Access Compliance Report

Public Rights-of-Way

(Curb Ramps)

Intersection ID: 30545	Main Street: COLONY_RD	Cross Street: STONECROFT_PARK_DR	Location:	N
ADA ID: DD03A00D41C7	Ramp Type: PerpDiag	Initial Pass/Fail: Fail	Overall Compliance: No	Severity Score: 22.5
Codes/Mitigation Info/Possible Solution		Field Measurements/Component Compliance

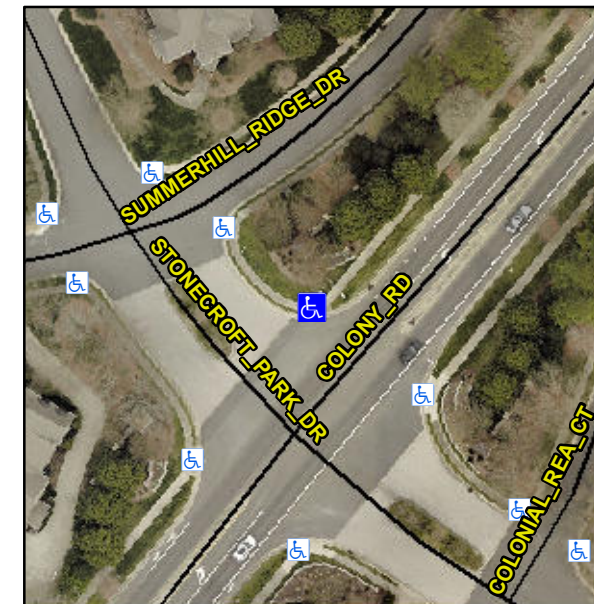
R304.5.1, R304.2.2, R304.5.3

Compliance	Description	Data	Compliance	Description	Data
N/A	Ramp Length (in)	68.0	No	Ramp Slope (%)	9.6
No	Ramp Width (in)	44.0	No	Ramp XSlope (%)	2.9
N/A	Flare Type LT	N/A	N/A	Flare Type RT	N/A
N/A	Flare Slope LT (%)	N/A	N/A	Flare Slope RT (%)	N/A
N/A	Flare Traversable LT?	N/A	N/A	Flare Traversable RT?	N/A
N/A	Landing Length (in)	N/A	N/A	DWS Provided?	N/A
N/A	Landing Width (in)	N/A	N/A	DWS Contrast?	N/A
N/A	Landing Slope (%)	N/A	N/A	DWS Length (in)	N/A
N/A	Landing X Slope (%)	N/A	N/A	DWS Full Width?	N/A
N/A	Landing Curb? (Y/N)	N/A	N/A	DWS Offset (in)	N/A
N/A	Shared Landing?	N/A			
N/A	Gutter Ponding?	N/A	N/A	Gutter Slope (%)	N/A
N/A	Gutter Lip Ht (in)	N/A	N/A	Gutter X Slope (%)	N/A
N/A	Painted X Walk1?	No	N/A	Painted X Walk2?	No
	X Walk 1 Direction	To SW		X Walk 2 Direction	To SE
N/A	X Walk 1 Width (in)	N/A	N/A	X Walk 2 Width (in)	N/A
	X Walk 1 Slope (%)	1.7		X Walk 2 Slope (%)	3.8
	X Walk 1 X Slope (%)	5.1		X Walk 2 X Slope (%)	1.4

N/A	Ramp inside XWalk1?	N/A	N/A	Ramp inside XWalk2?	N/A
	Road Slope (%)	0.9	N/A	Clear Space?	N/A
	Road X Slope (%)	4.9	N/A	Clear Space to XWalk (in)	N/A
N/A	Any Obstructions?	N/A	N/A	Storm Grate/Utility Hazard?	N/A
	Obstruction Type			Storm Grate/Utility Type	
		N/A			N/A
			Yes	Surface Condition? (G/P)	Good

Remove & Replace Curb Ramp With Two New Directional Ramps or Equivalent.
